HISTORIC DISTRICT COMMISSION
STAFF REPORT

5:30 pm • October 22, 2018 • City Hall

**OLD CONWAY DESIGN OVERLAY DISTRICT
CERTIFICATE OF APPROPRIATENESS REVIEW
FACADE RENOVATION
713-719 FRONT STREET**

**OLD CONWAY DESIGN OVERLAY DISTRICT
CERTIFICATE OF APPROPRIATENESS REVIEW
GARAGE & COVERED WALKWAY
1614 COLLEGE AVENUE**

Elevations and Perspective

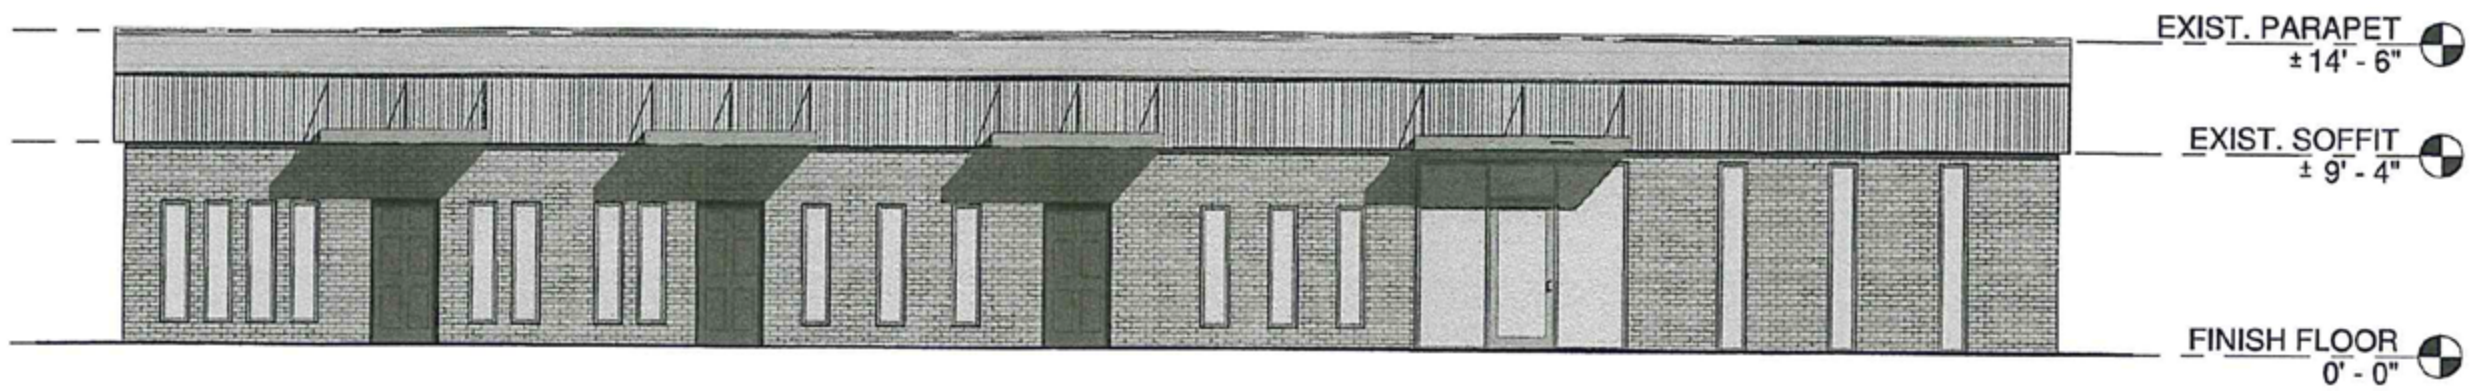
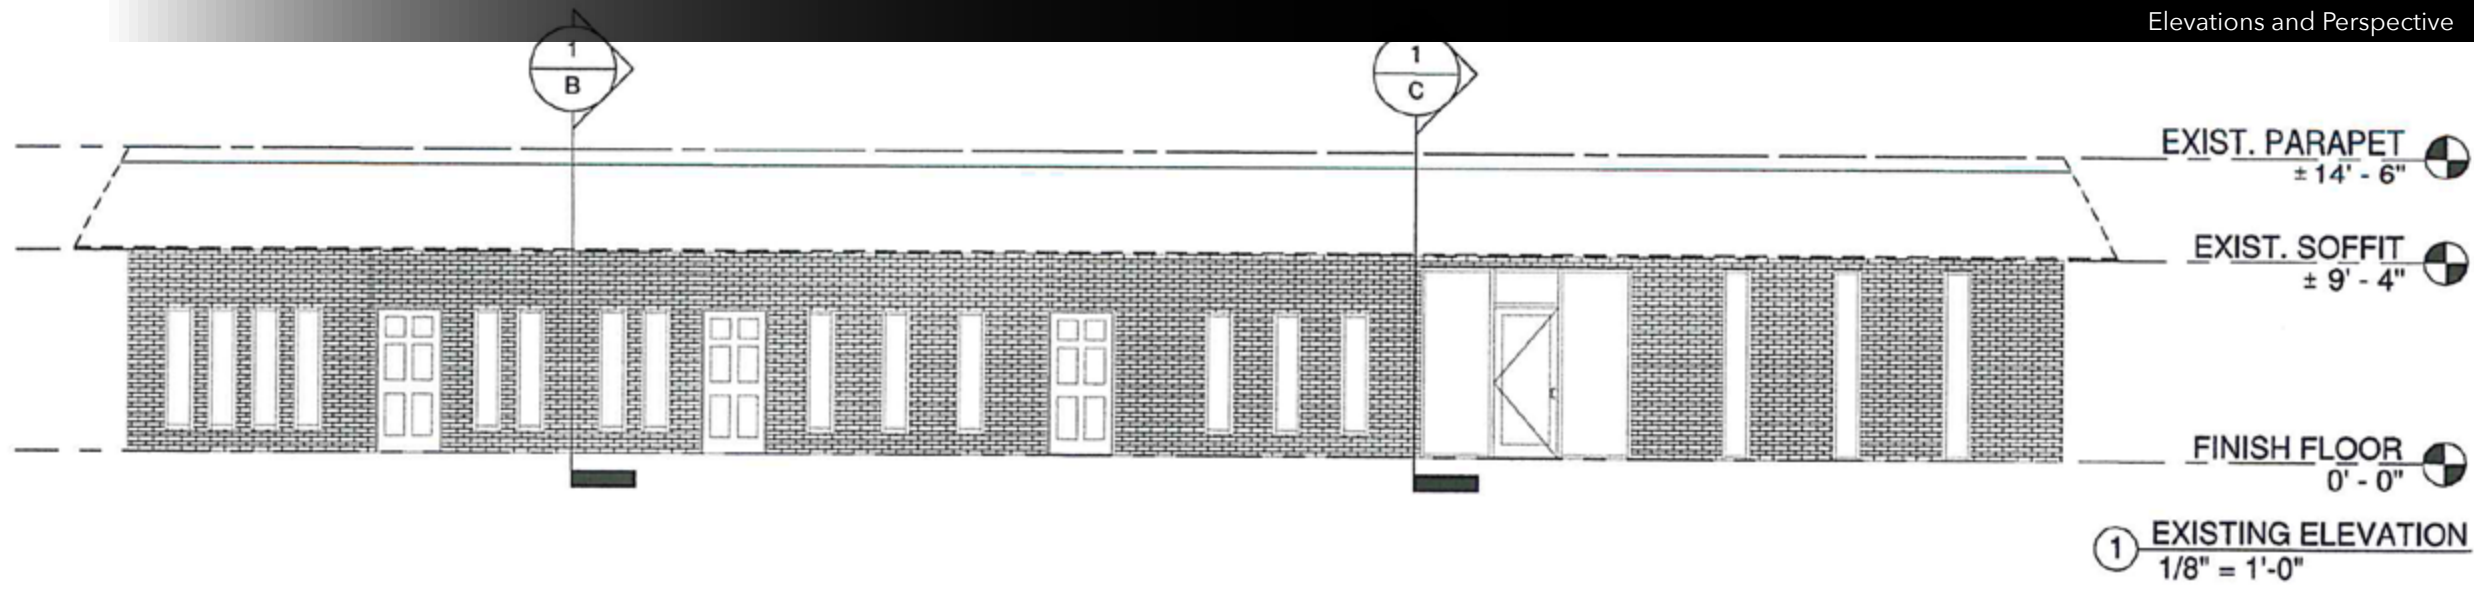
Directional expression. Measurement of the height to width ratio of a structure's elevation. The height/vertical expression of the residence will become slightly more vertical in nature. The existing mansard parapet creates a more horizontal residential appearance. A new vertical parapet will give the structure a taller feel.

Complexity of form. The level of detailing and breaks in wall planes of a structure. The structure is mid century and has little detailing. The mansard roof does little to emphasize the entrances and creates a horizontal feel. The proposed parapet will add a new level of detailing through the use of a band with vertical elements topped capped by a horizontal band. This adds a new more complex vertical detailing to the structure.

Style. The style should compliment the existing and area structures. The structure is a mid-century structure. The mansard parapet is somewhat reflective of the time period in which it was constructed. However, the mansard parapet does not blend well with area historic buildings.

Awnings. When new construction uses awnings, traditional awning designs, materials, and placement should be used. Aluminum awnings are proposed over the entry doors. Aside from providing protection from rain, these awnings emphasize the entry areas. The awning are appropriately sized to the door and windows below.

Architectural Details, Siding, and Bricks. Eaves, brackets, dentils, cornices, molding, columns, trim, etc. The existing structure is simple in nature. A brick face is broken up with narrow vertical windows and doors. The new vertical parapet will add a new level of detailing not currently offered by the mansard roof parapet. The proposed parapet material is metal arranged both vertically and horizontally. The majority of the covering is vertical. Metal in this fashion is not a traditional parapet treatment. However, this is not a historic structure. In this application, metal is probably the most appropriate material. Modern EIFS or traditional stucco could be used however, these materials would likely not offer the longevity of a metal material. Metal could also be seen as more fitting with the mid-century style of the structure.

Staff recommends approval of the new parapet with the following conditions:

1. The parapet shall be constructed as shown on the submitted plans.
2. Metal siding material and aluminum awnings as presented shall be allowed.

Elevations and Floor Plan

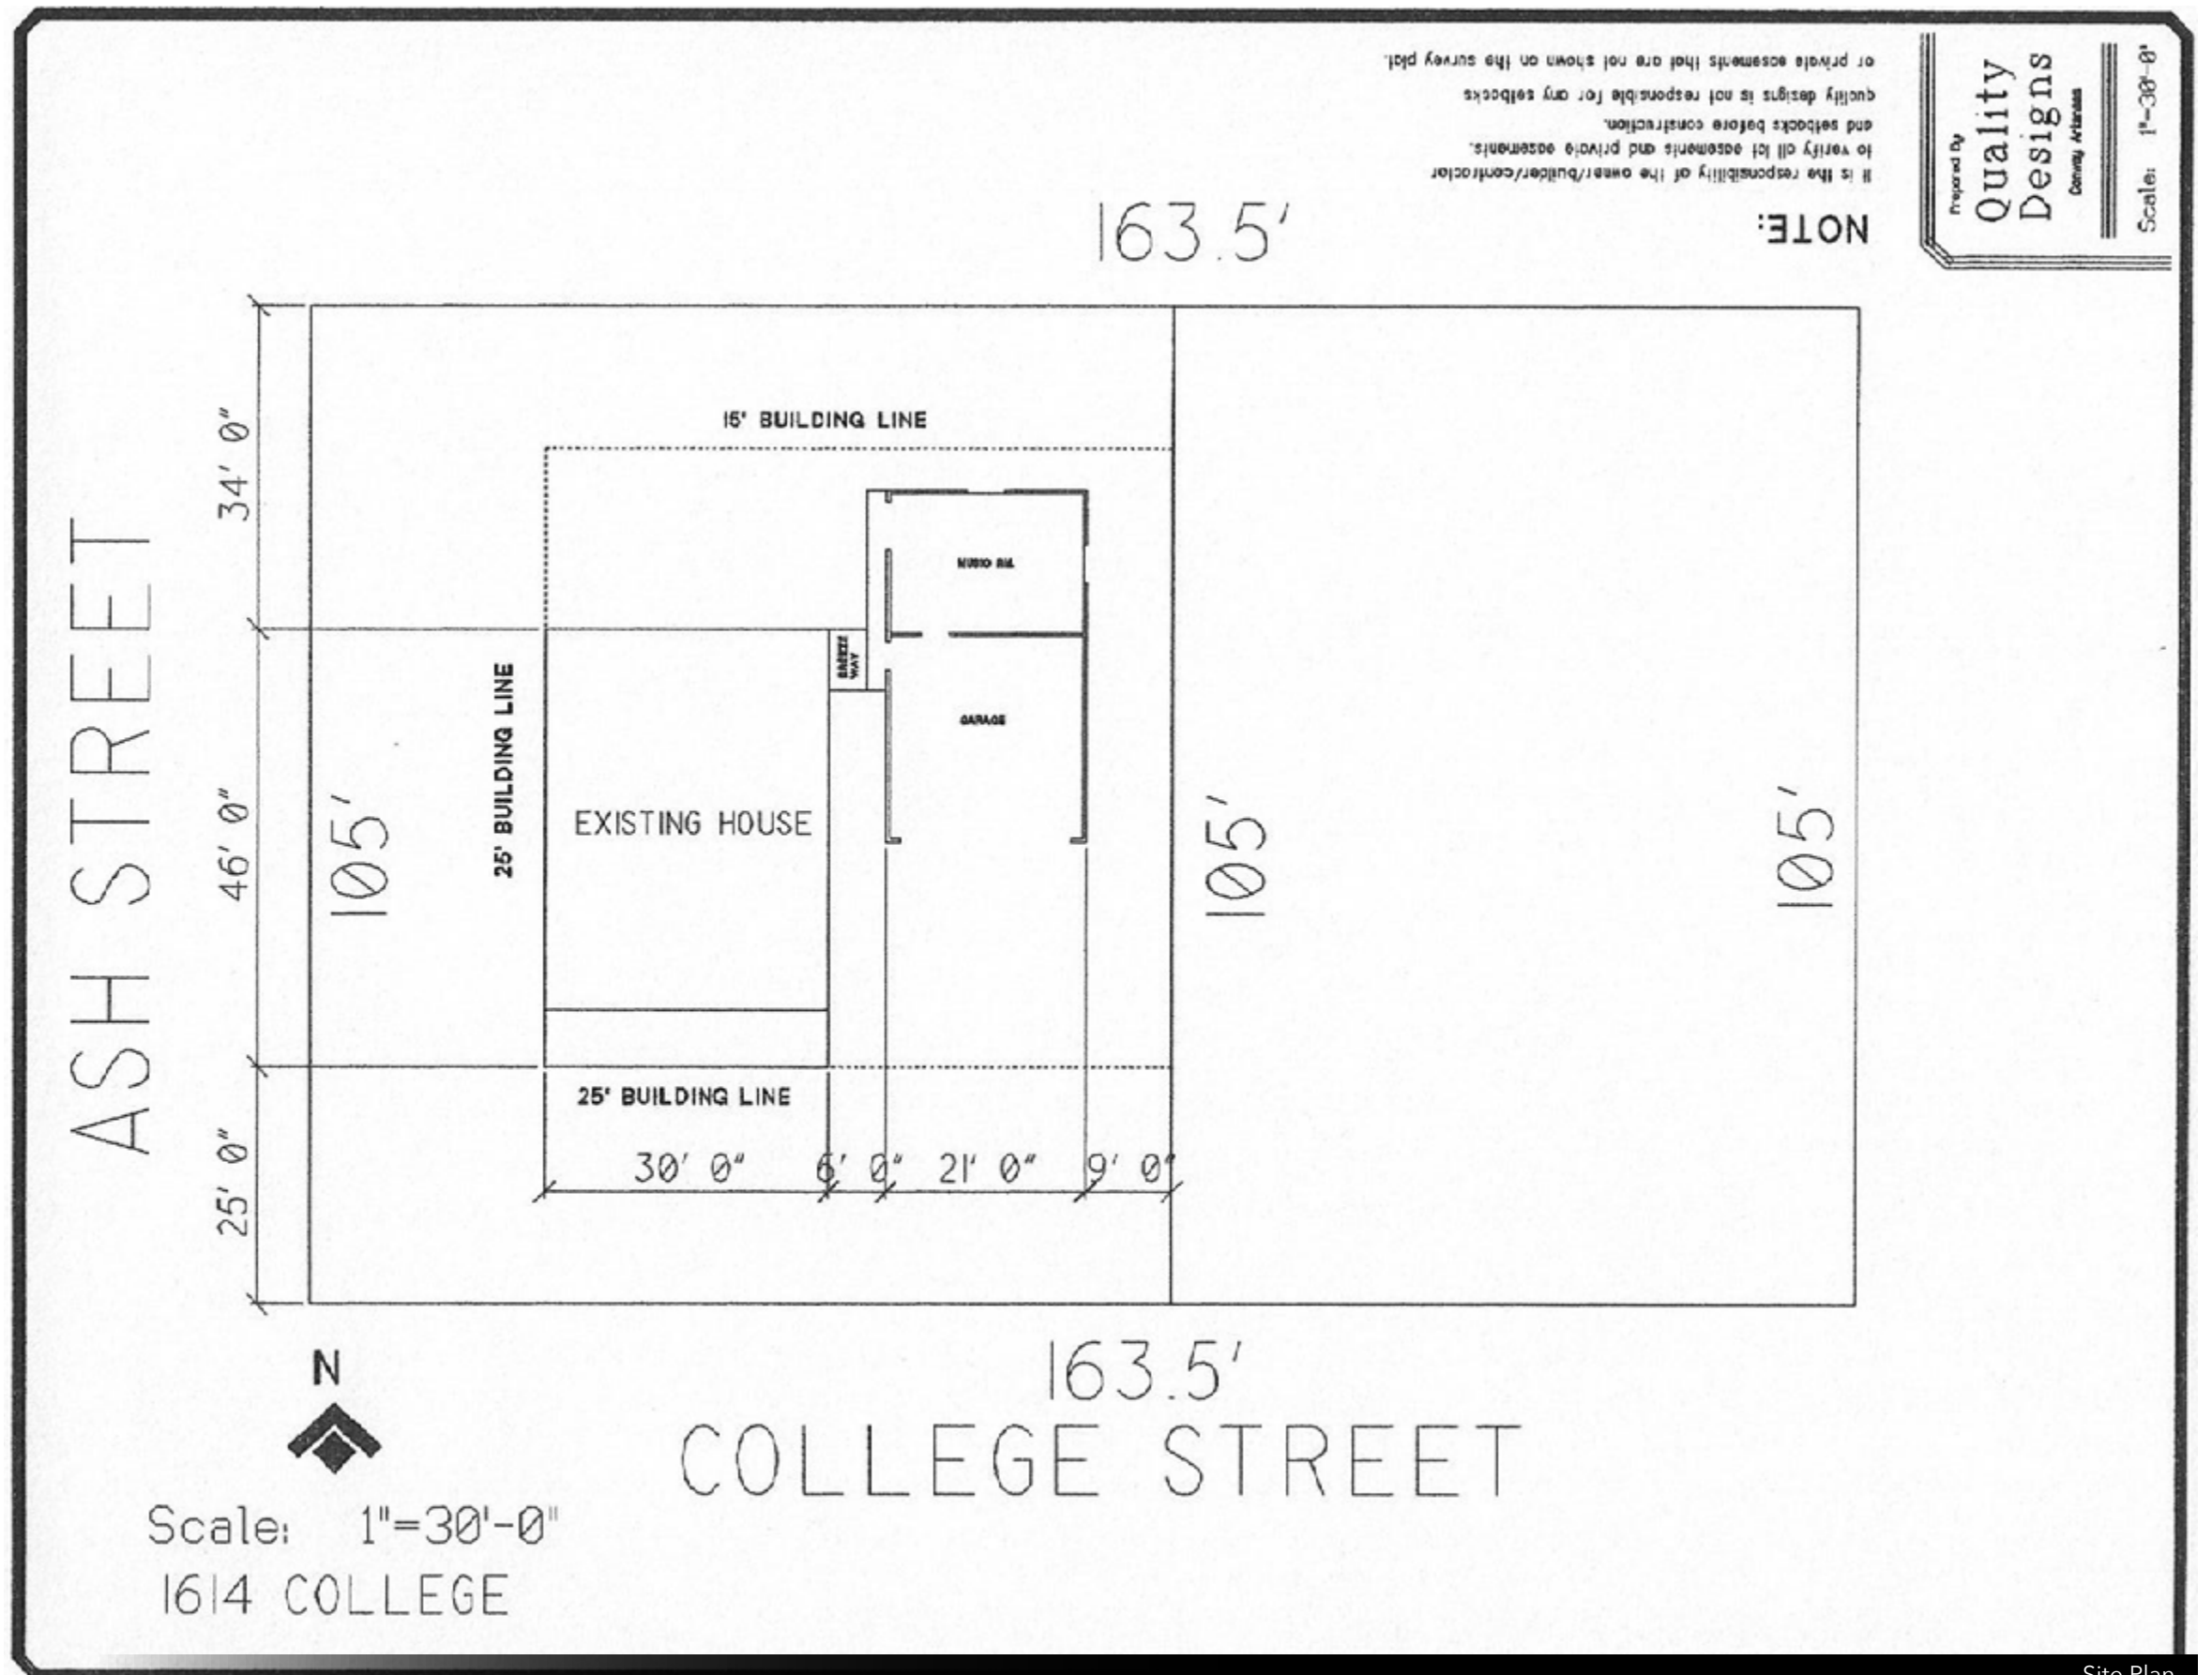
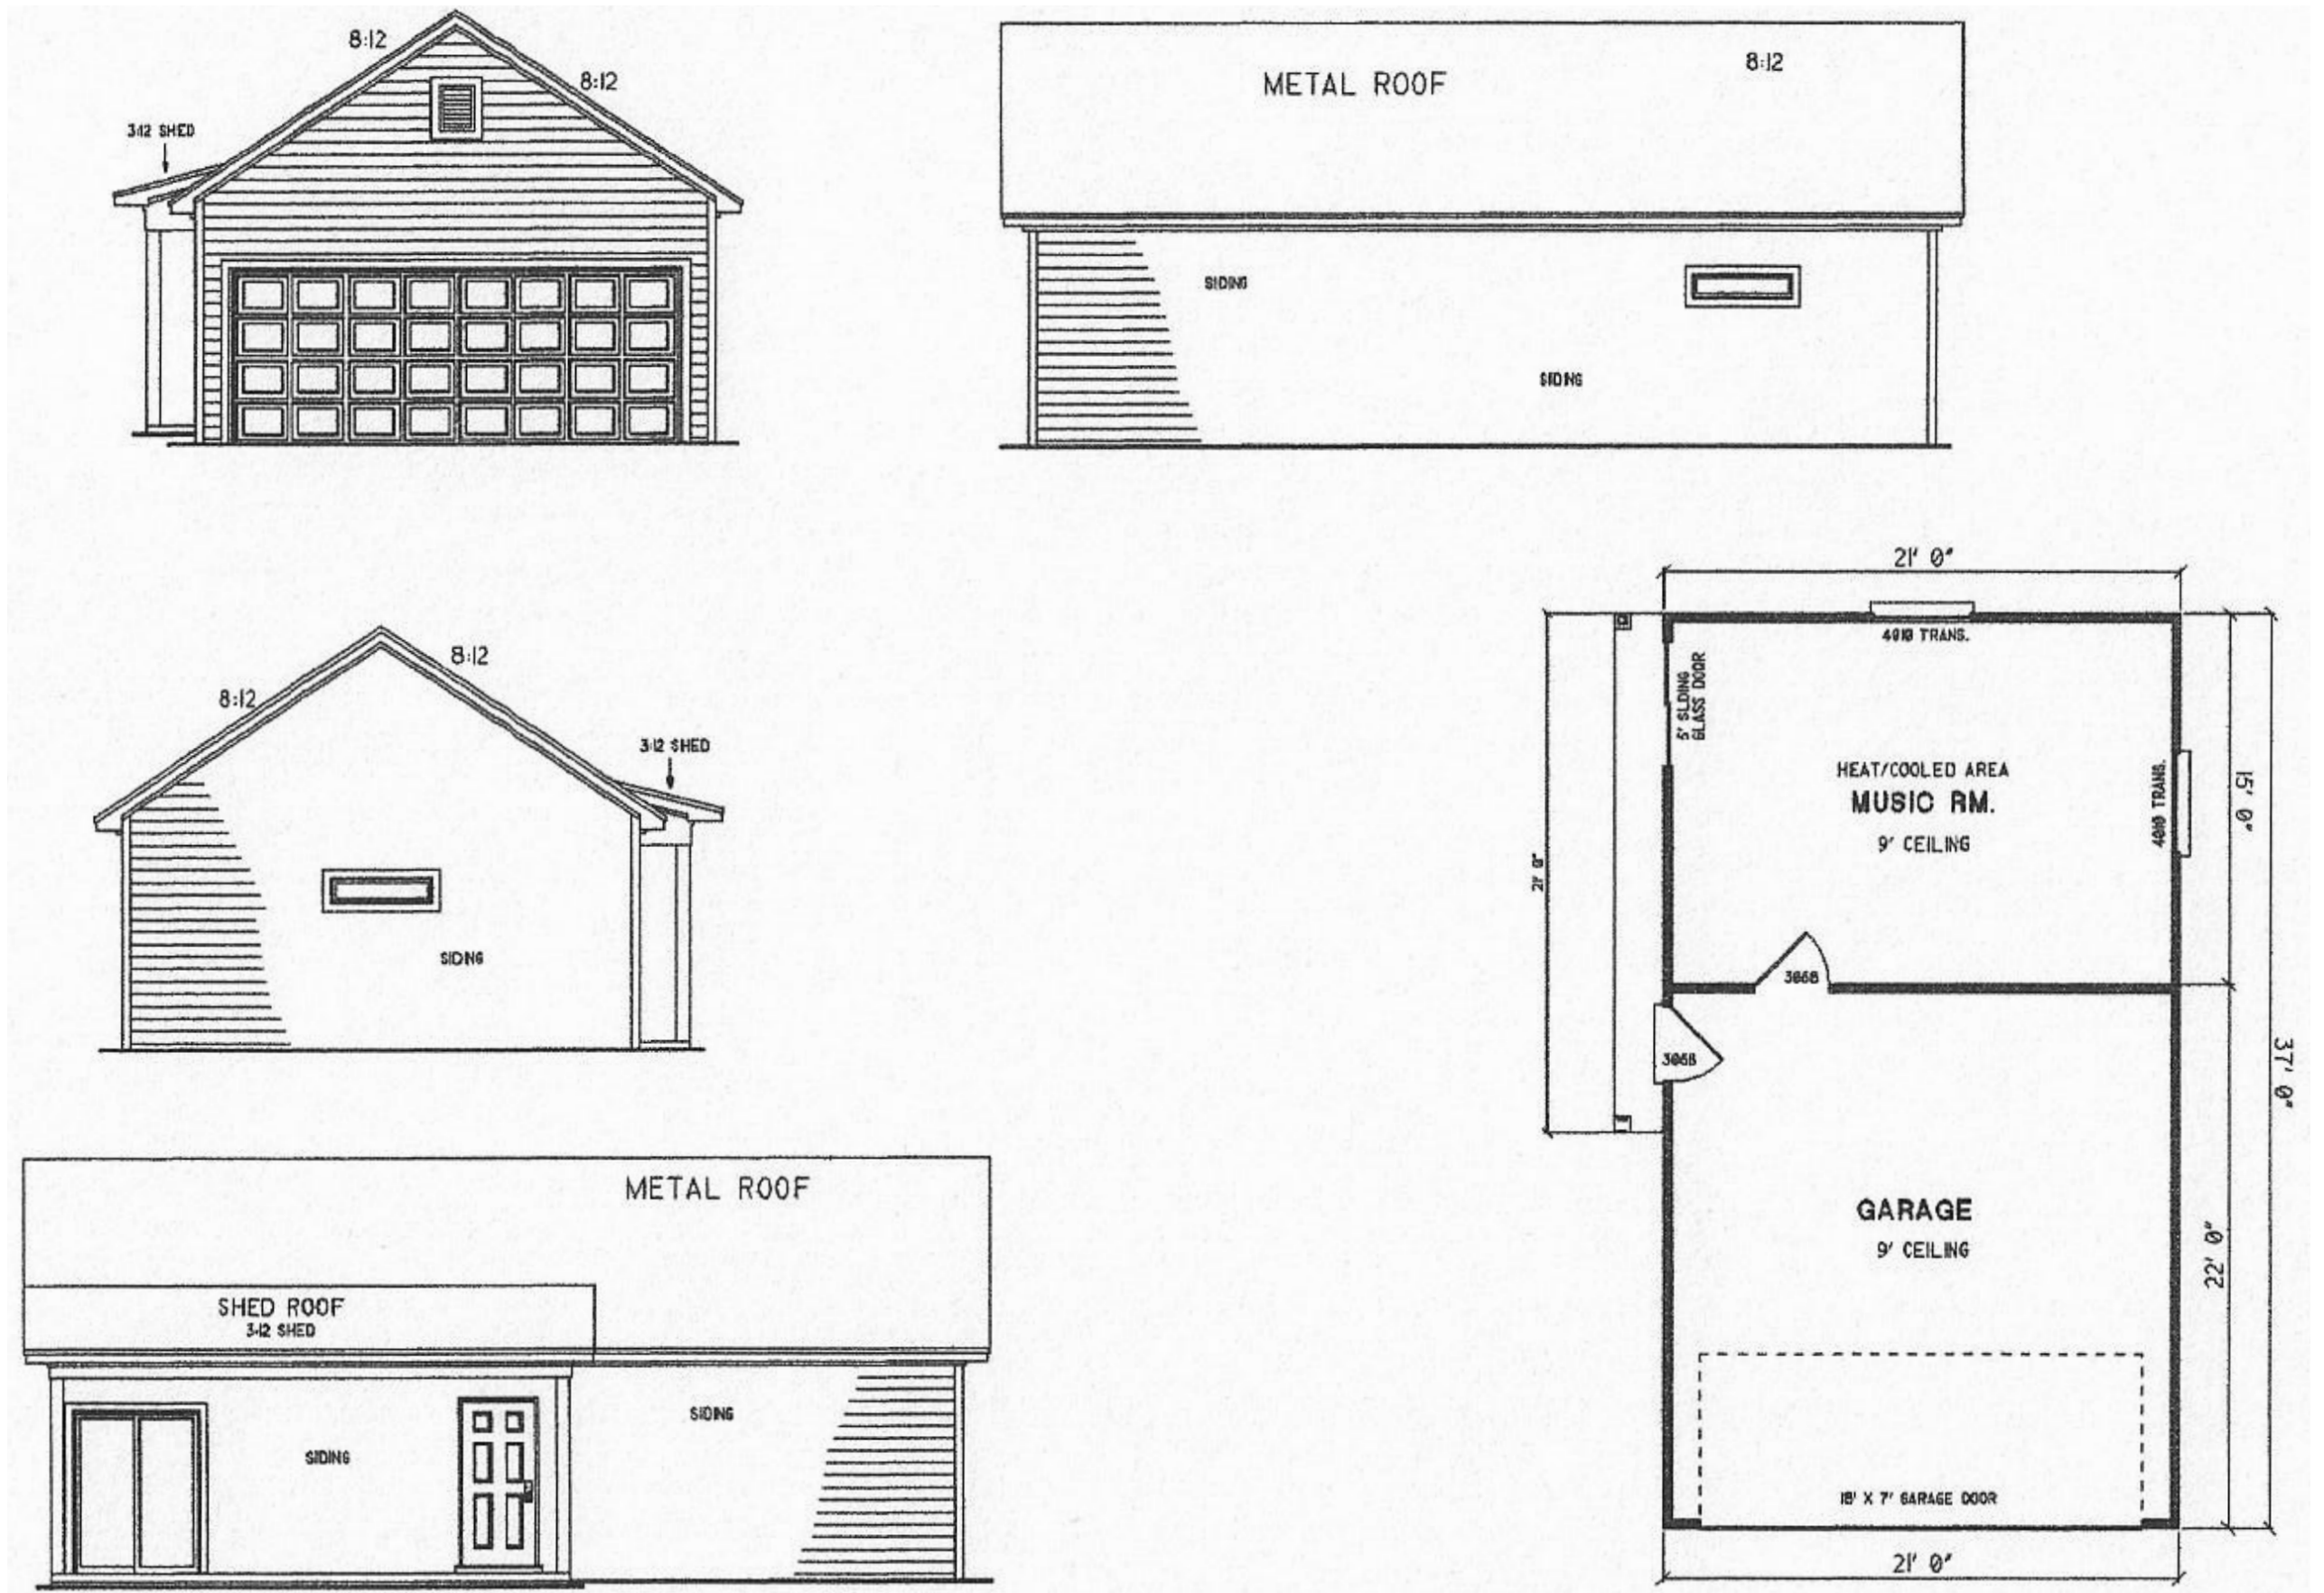
Style. The style should compliment the existing and area structures. The residence is one story craftsman style. The garage does not have any craftsman elements, but as a utilitarian structure its style does not detract from the home.

Entries, Porches, and Porticos. The garage will have a double car width door. With the garage is at the midline of the residence, this large door shouldn't overpower the facade of the existing residence.

Doors and windows. Two small windows are proposed on the north and east facades of the garage. These windows are modern in nature, but as windows on an accessory building and placed on largely unseen facades, they are appropriate. Two side entry doors are shown on the west side of the garage.

Architectural Details, Siding, and Bricks. Eaves, brackets, dentils, cornices, molding, columns, trim, etc. The existing residence has horizontal siding, wide trim, and open rafter tails. The proposed garage plan also shows horizontal siding, trim around windows, but no rafter tails. As a more utilitarian structure this should blend with the existing residence. The type of siding material is not specified. Per Old Conway Design Overlay regulation, vinyl should not be used.

Staff recommends approval of the new garage with the following conditions:

1. The garage and breezeway shall be constructed as shown on the submitted plans.
2. Metal roof matching existing shall be used.
3. Horizontal cement board siding shall be allowed.
